DUKE POWER COMPANY

Reference: McGuire Nuclear Station
Docket Nos. 50-369, 50-370

Please find attached additional information concerning the McGuire Nuclear Station spent fuel pool two region rerack modifications. This additional information was requested by a June 11, 1984 telecopy from Franklin Research Center to Duke Power which concerns the spent fuel pool structural analysis.

DUKE POWER COMPANY
MCGUIRE NUCLEAR STATION
Spent Fuel Pool Rerack Modifications
Additional Information

Sample Calculation

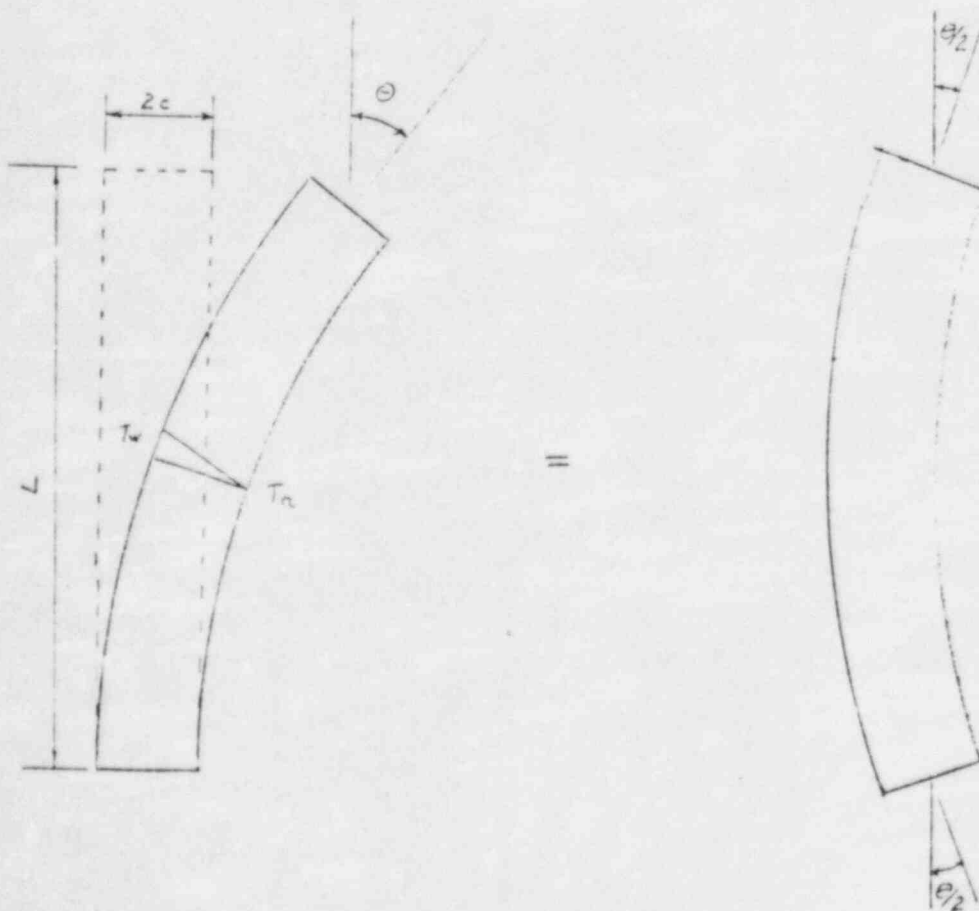
The licensee has stated that the thermal gradients were determined by the use of 'ANSYS finite element computer code,' for analysis by 'STRUDL program.' Please indicate if the analysis was based on uncracked or cracked sections, and provide sample calculations.

Thermal gradients are determined via ANSYS thermal analysis as indicated in Section 3.1 of the license submittal. Thermal gradients then are used to derive thermal growth and rotational distortions. It is then determined what moments must be applied to result in zero net end rotation. These moments are applied step-wise. Reduced flexural stiffness is accounted for if moment in the member exceeds that required to cause cracking. The final moment required to obtain zero net end rotation is applied to the structure through member end loads.

Calculate end rotation of cantilever member

$$= \frac{\alpha \times (T_w - T_a)}{2c} (L)$$

Rotate ends until $\theta = 0$ allowing for varying stiffness as cracks propagate through the member.

The Moment - end rotation relationship is obtained by creating a beam model in STRUDL composed of short beam segments all initially with equal member properties. As ends are rotated, a moment develops in the beam segments until $M = M_{cr}$. Beyond this point, additional rotation results in cracking of the beam at constant moment = M_{cr} , until the entire member is cracked. This phenomenon is accounted for by changing the properties of individual beam segments as the end rotations are increased in step-wise fashion. Once the entire member is cracked, further end rotation results in increasing Moment at a reduced rate. Thus a given thermal rotation, restrained by end fixity can be related to an applied end moment.
